Item No. 8.1.1
Design Review Committee
August 18, 2016

SUBJECT: **Case 20560: Amended Substantive Site-plan Approval Application – Nova Centre, Lands bounded by Argyle, Market, Sackville, and Prince Streets, Halifax**

SPA-001

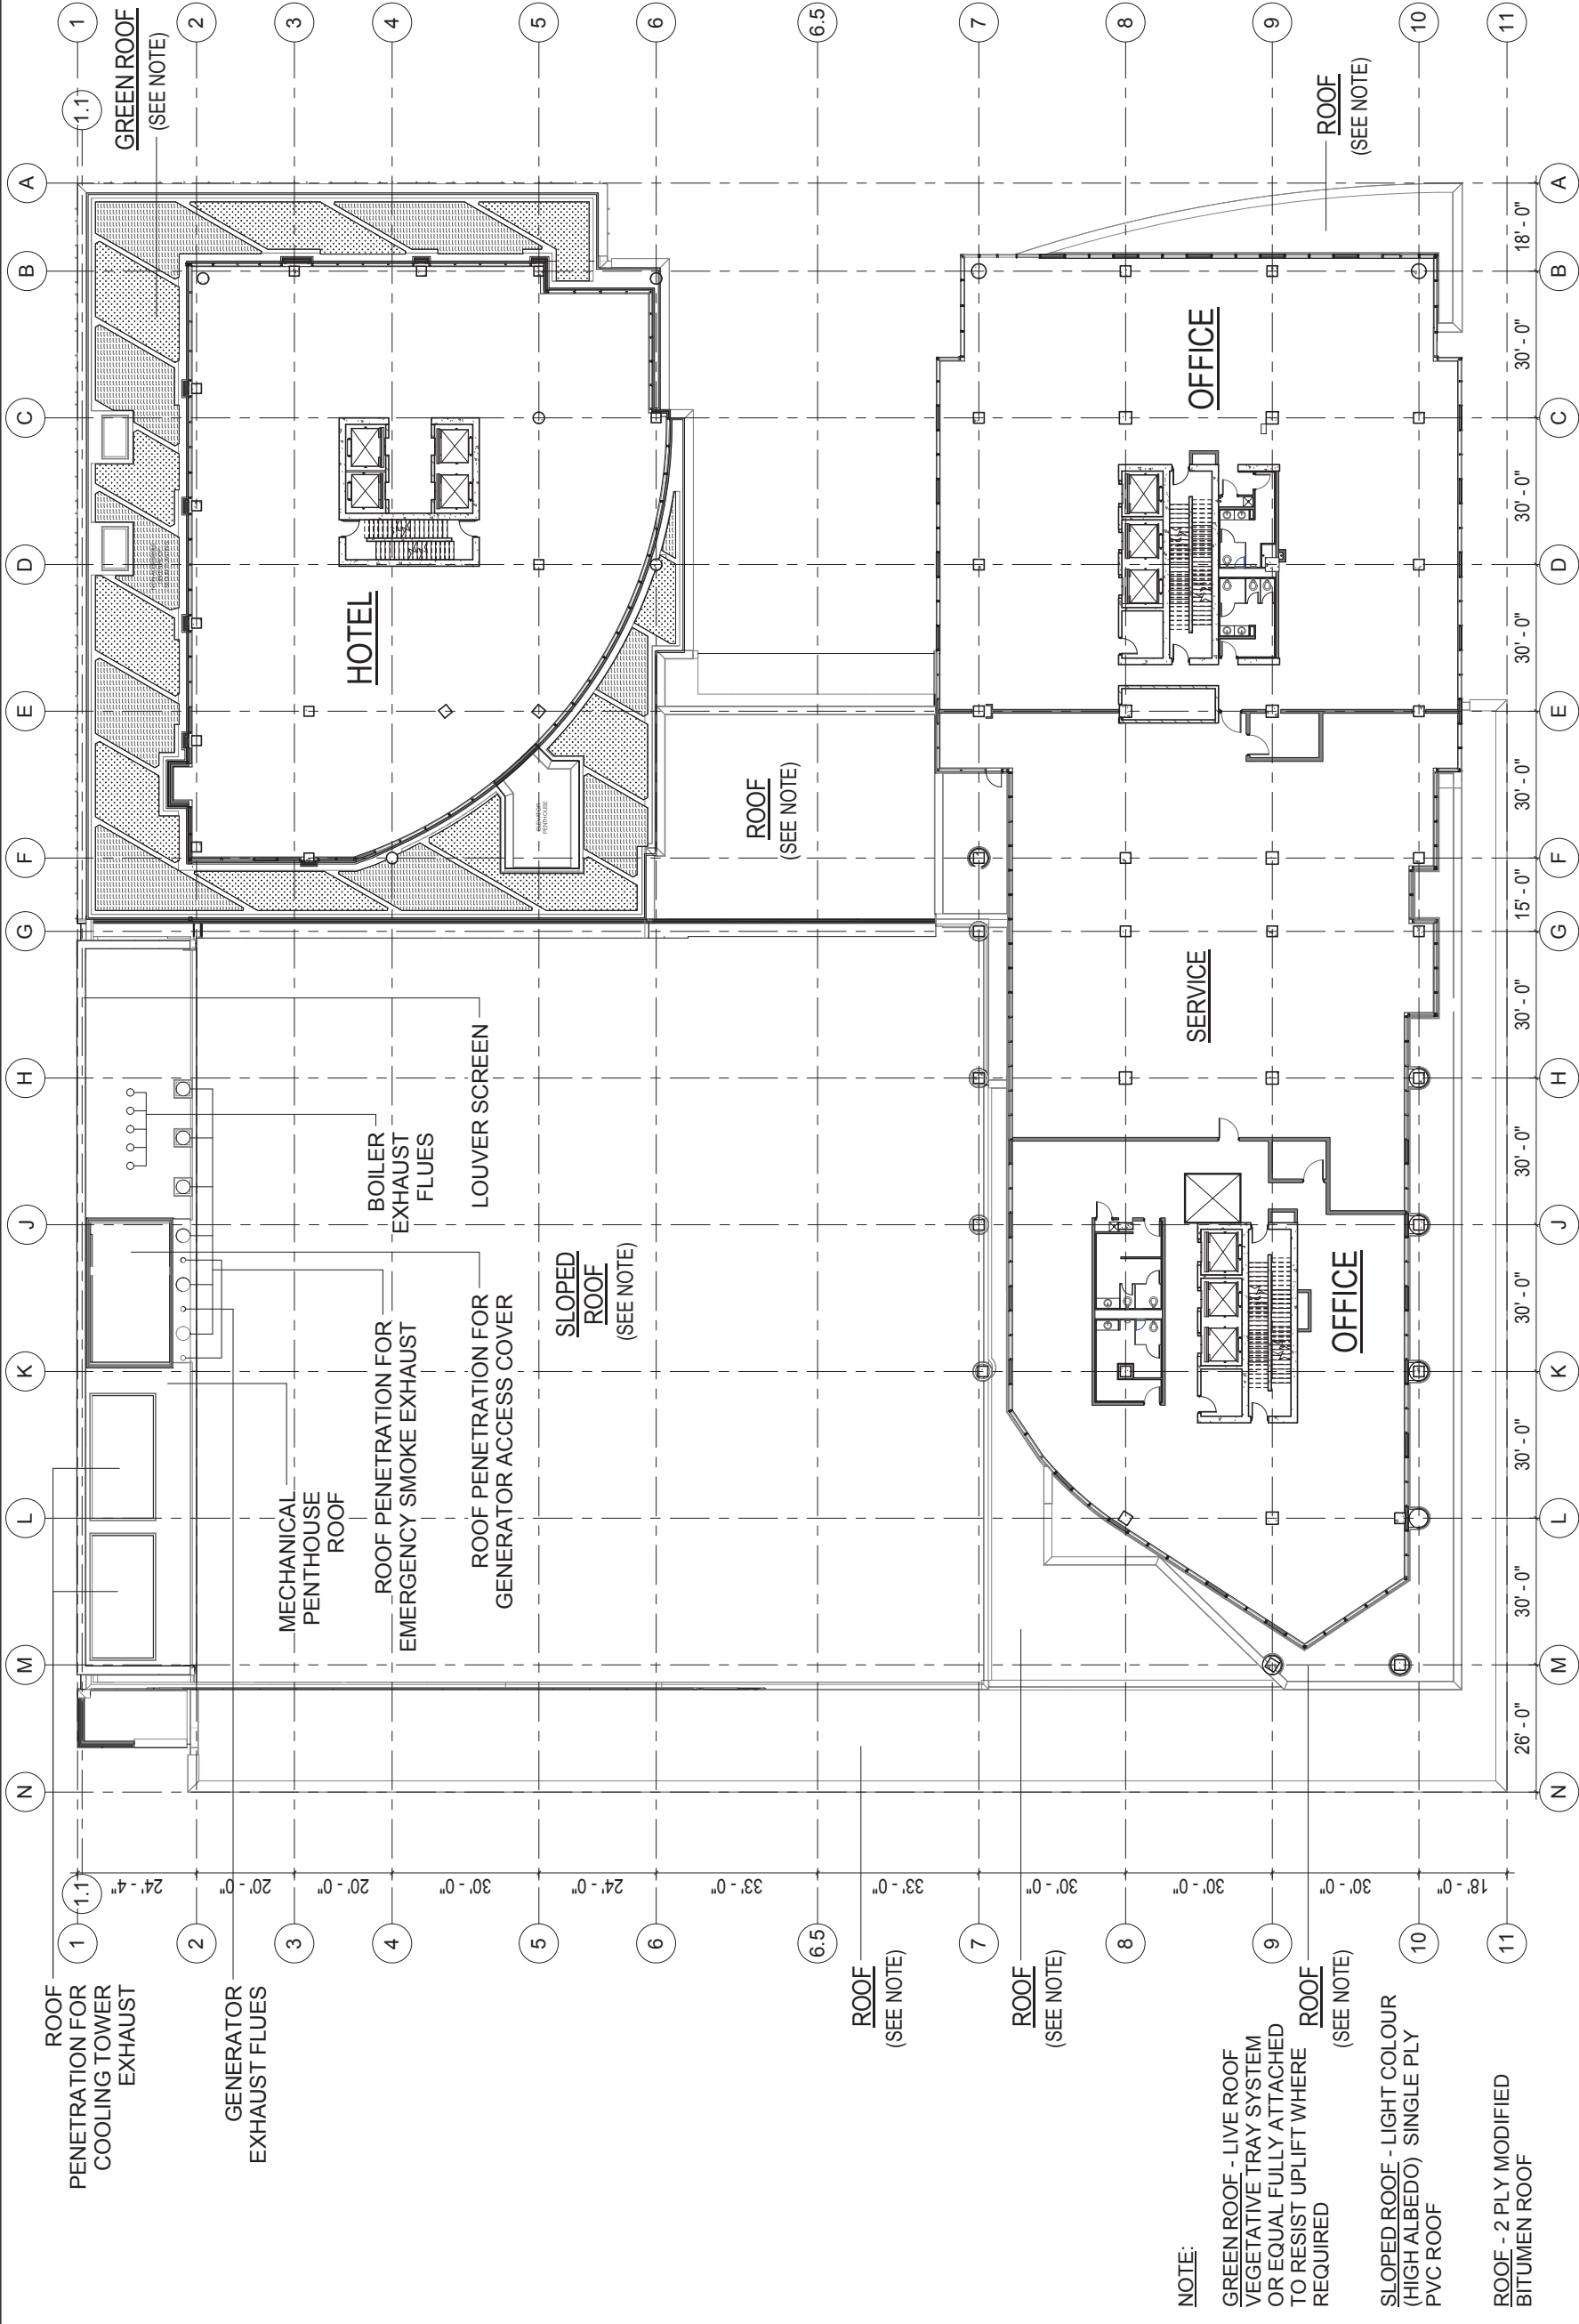
The applicant is requesting to increase the building height from 22 m to 23.56 m (see Attachment A, Plan No. SPA-001) for the proposed rooftop mechanical equipment in the vicinity of Market Street. In support of its request, the applicant provided the following information:

The rooftop architectural feature can be considered to be the louvres that are being installed to screen the mechanical equipment. The louvre panel does not extend to the full height of the mechanical equipment. While it will not be immediately apparent from Market Street, it will be visible from other vantage points, including the upper storeys of other adjacent buildings and higher elevations. Although this is not ideal, as noted previously, the mechanical equipment occupies a relatively small area of the sloped roof.

- b. the additional building height is for rooftop architectural features and the additional height does not result in an increase in gross floor area;

SPA-005

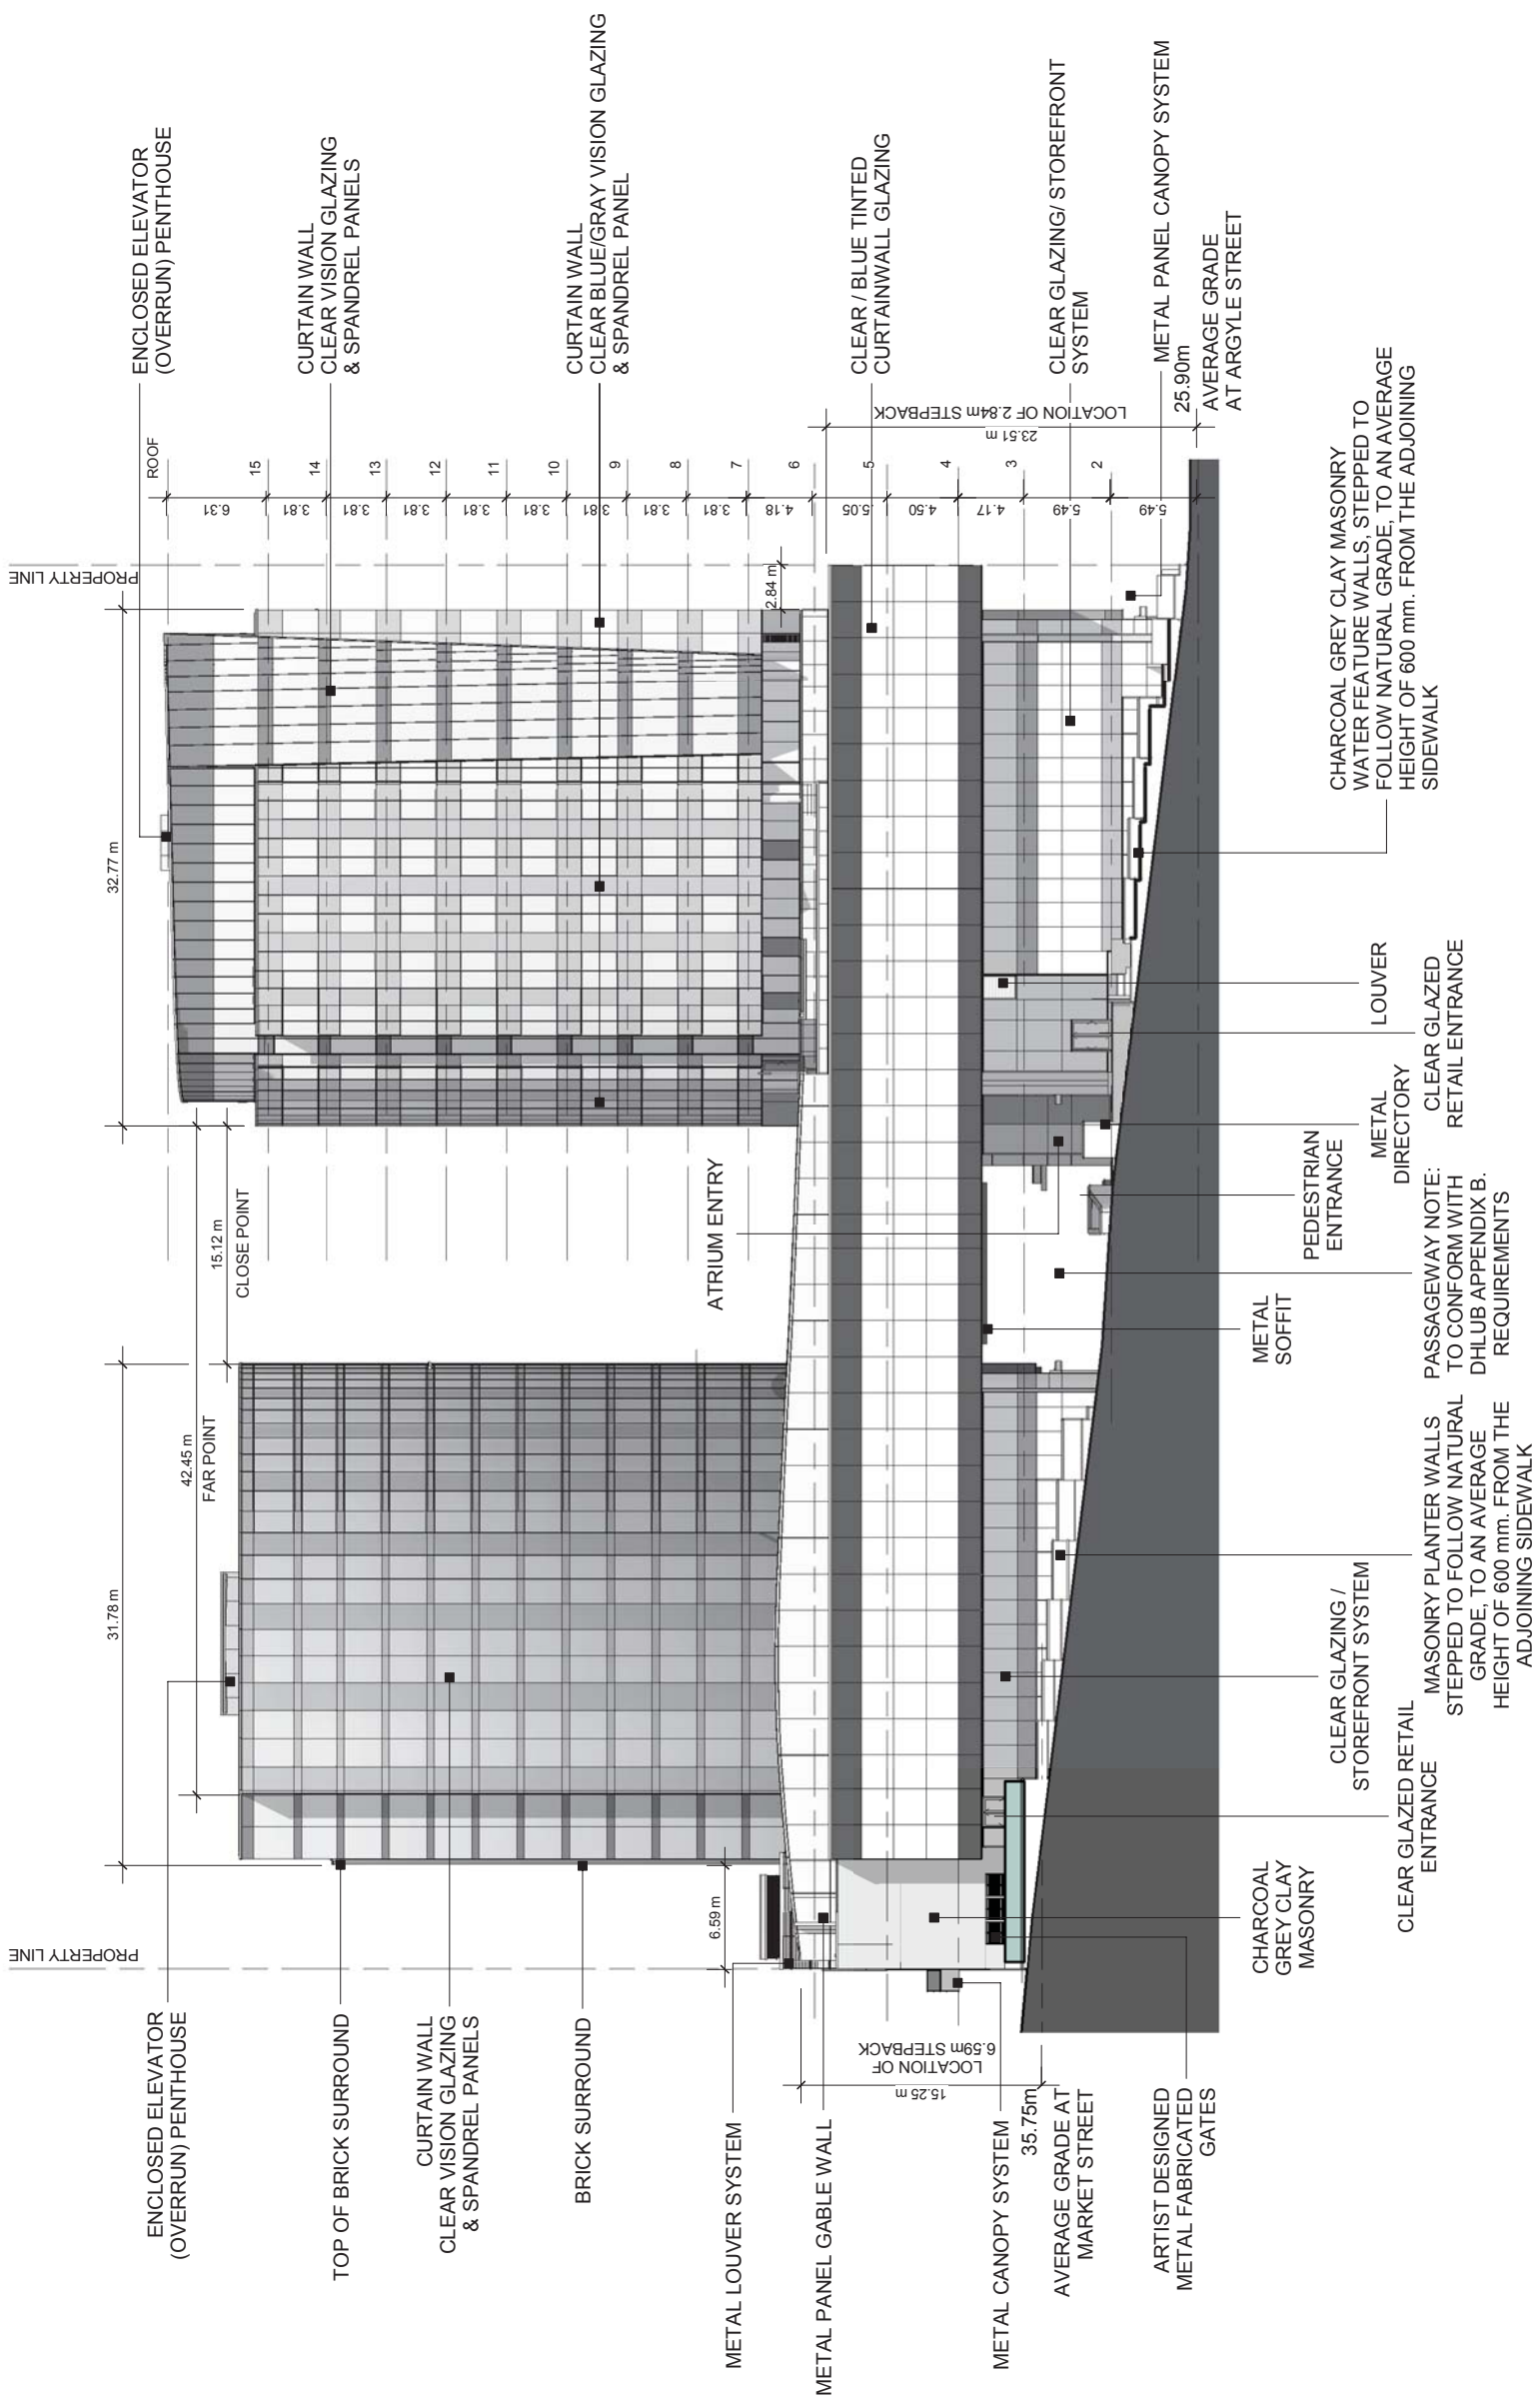
7. Delete decorative 'punched' windows from north and west elevations:
This modification was made as a result of changes to the Convention Centre programming which increased the output of food service, and in turn substantially increased the size of the kitchen.

13. Glazing at the west elevations of the hotel podium has been modified to accommodate additional louvers. Aluminum "fins" have been incorporated to

SPA-006

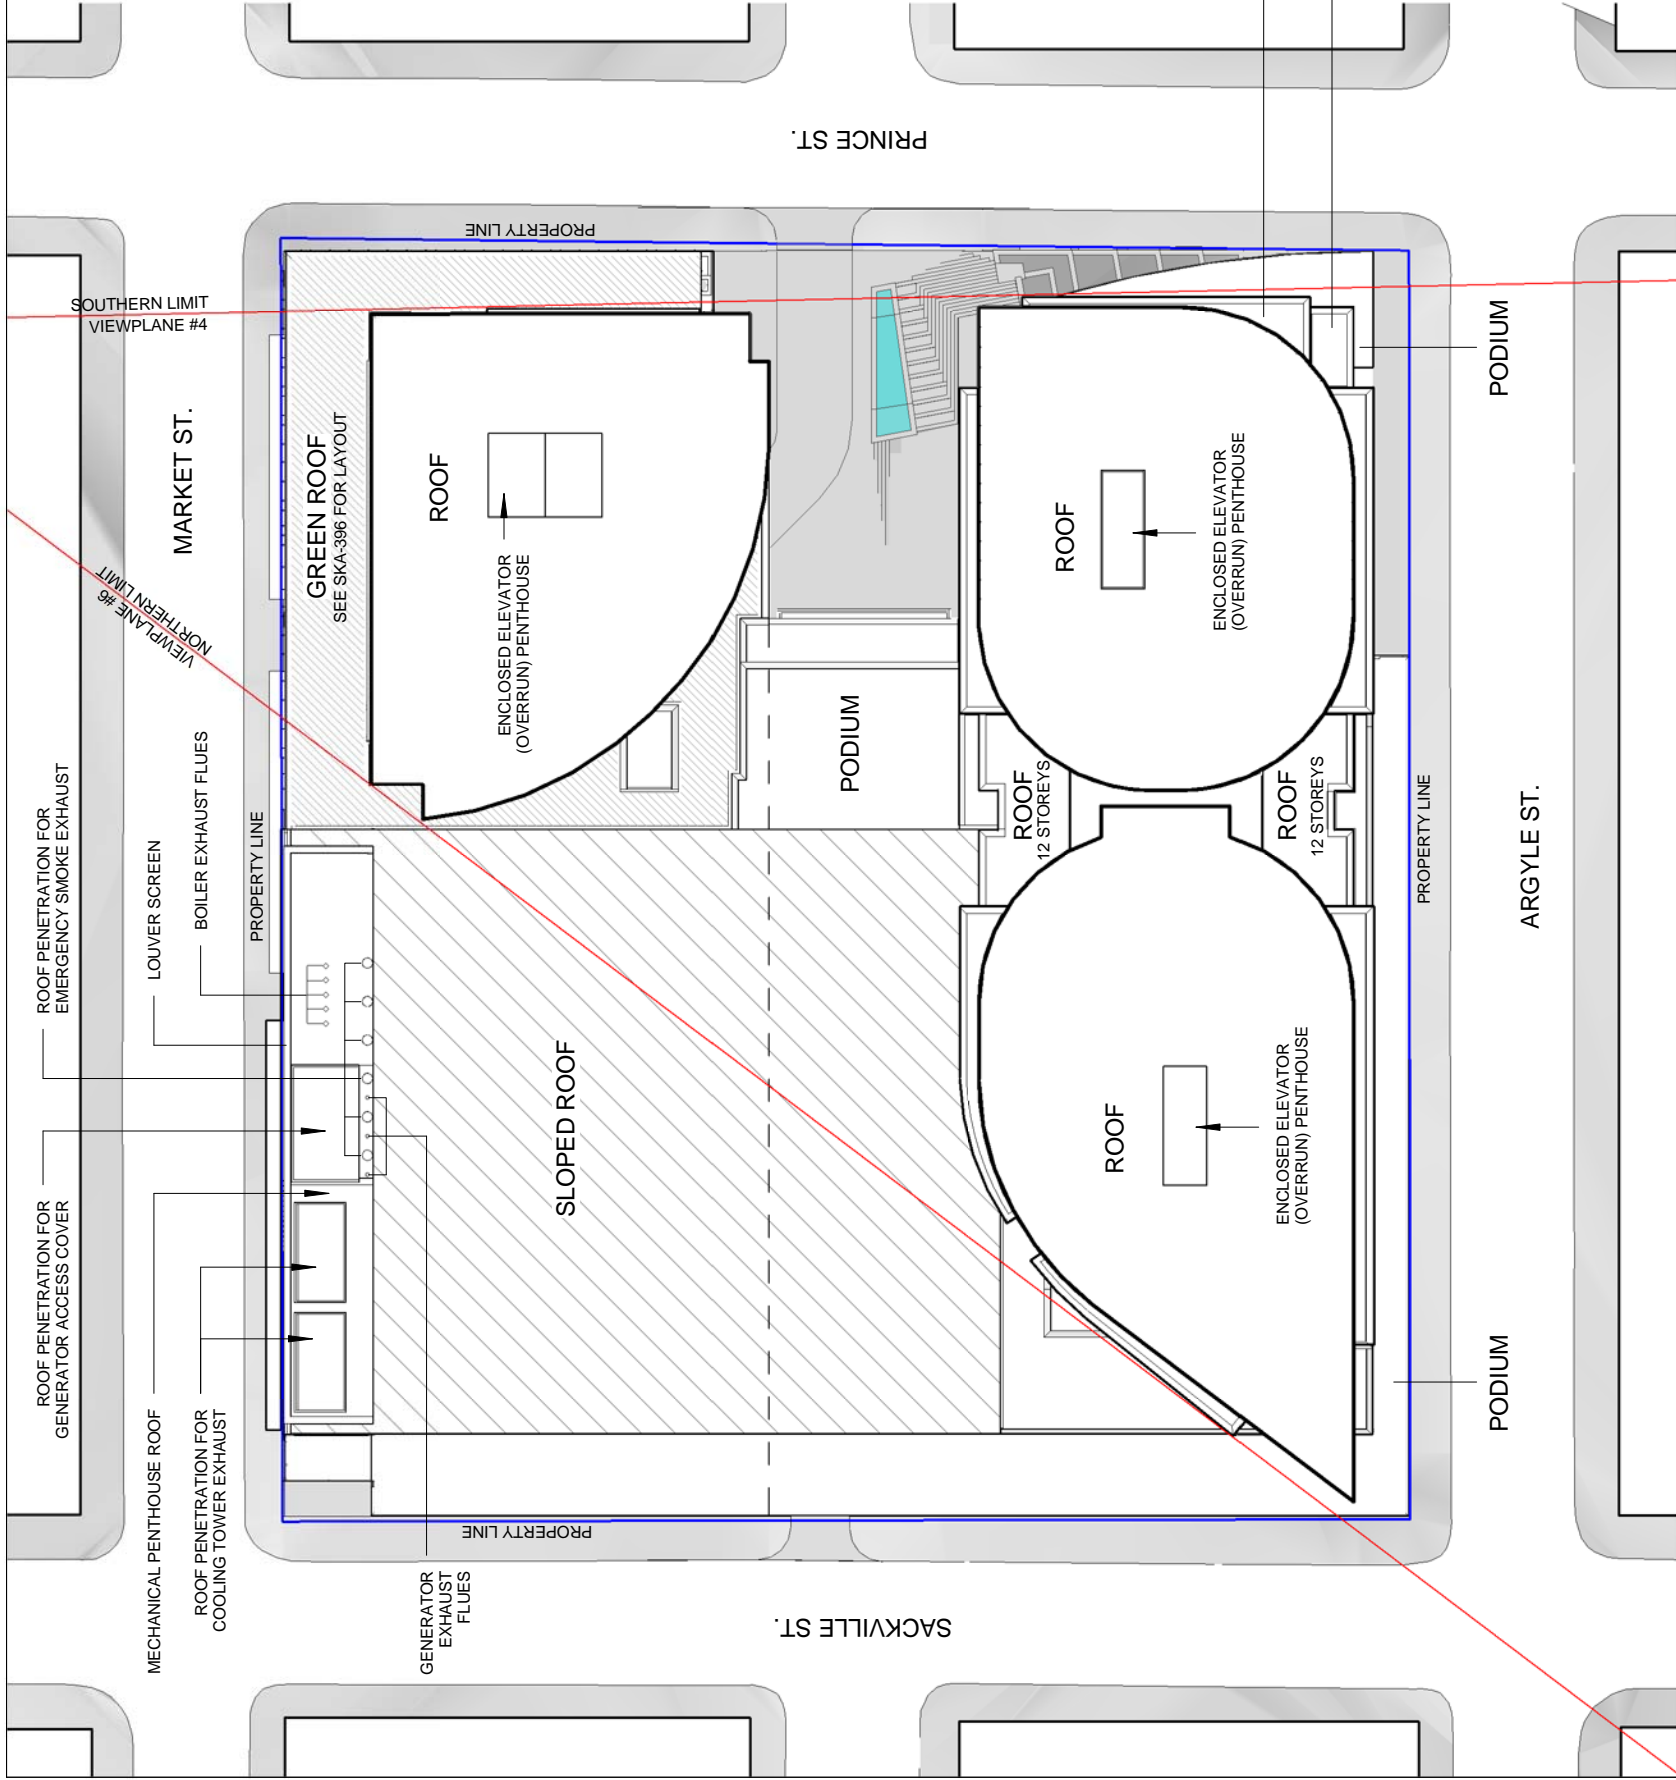
- a) that the garage doors facing Market Street, open within the interior of the loading bay areas and be comprised of translucent materials and canopies be provided above the said doors; and
 - b) the square windows shown on the Market Street and Prince Street podiums on the June 3 2014 Site-plan Approval Plans continue to be required.
2. Approve the variance to the building height for rooftop mechanical equipment upon the sloped roof of the building in the vicinity of Market Street.
